# Remarks on Stream FEC for Ethernet

# Errors Duplication, lower Burst Protection

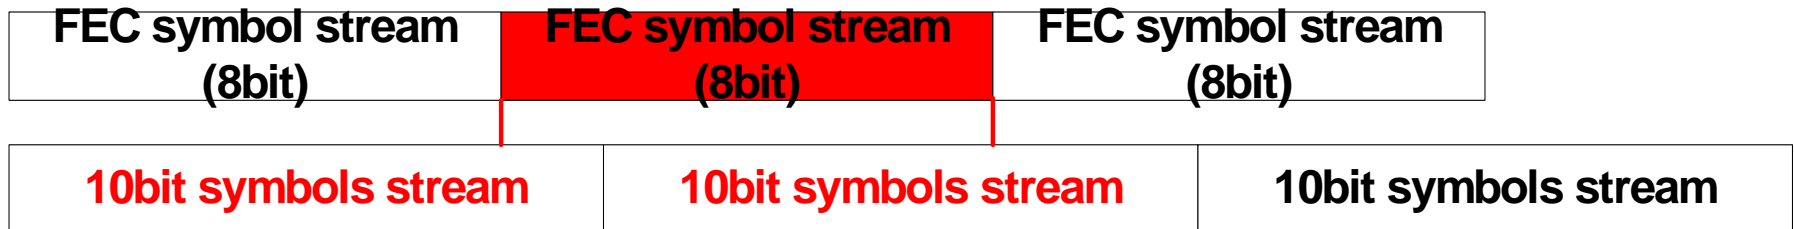
- A single error over protected stream may be translated to two errors after detection
- Maximal error burst protection is decreased to 64 bits (from 80 bits in F-FEC)
